PUBLIC INTEREST REVIEW FOR GROUNDWATER APPLICATIONS

TO: Water Rights Section Date 8/13/2015
 FROM: Groundwater Section Jen Woody Reviewer's Name
 SUBJECT: Application G- 18003 Supersedes review of 3/17/2015 Date of Review(s)

A. GENERAL INFORMATION: Applicant's Name: Woodburn Organic Farms LLC County: Marion

A1. Applicant(s) seek(s) 0.49 cfs from 2 well(s) in the Willamette Basin,
Molalla - Pudding River subbasin Quad Map: Woodburn

MARI 1762, MARI 1813 and Pudding River

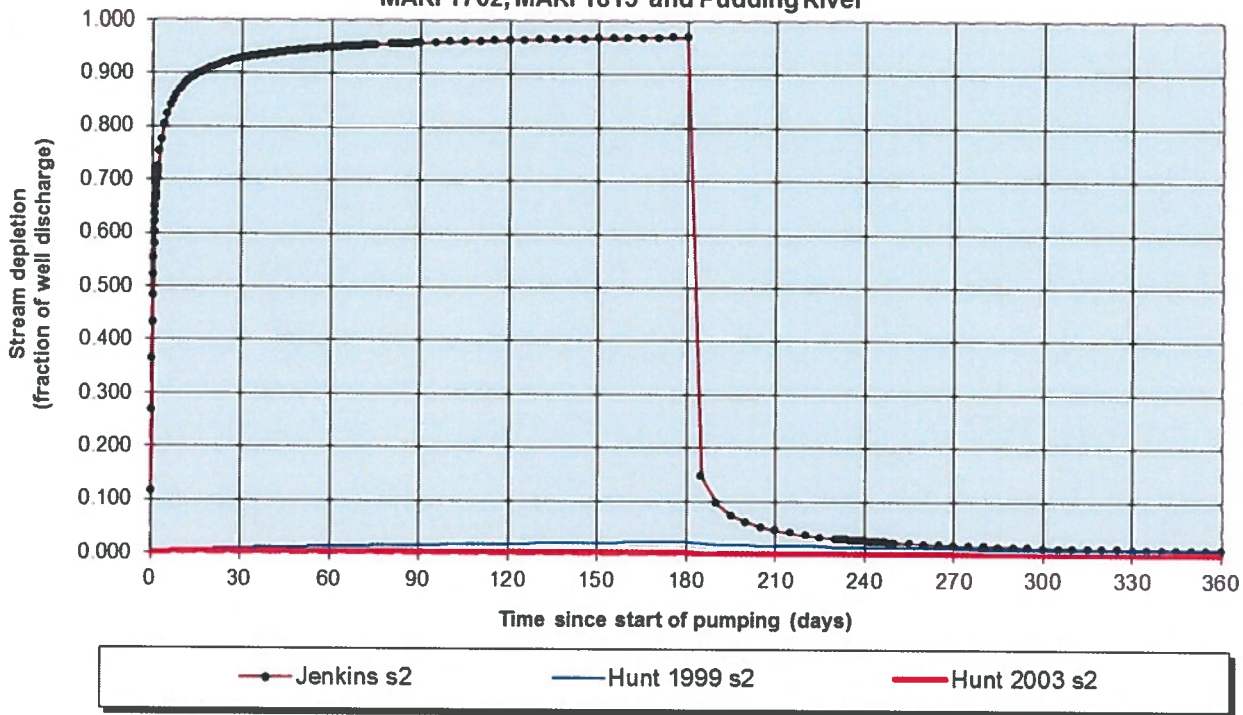
Because the Willamette Silt acts as a resistor to streambed flux, calculated stream depletion using the Hunt 2003 model indicates interference with the Pudding River at 30 days is much less than 25% at both wells.
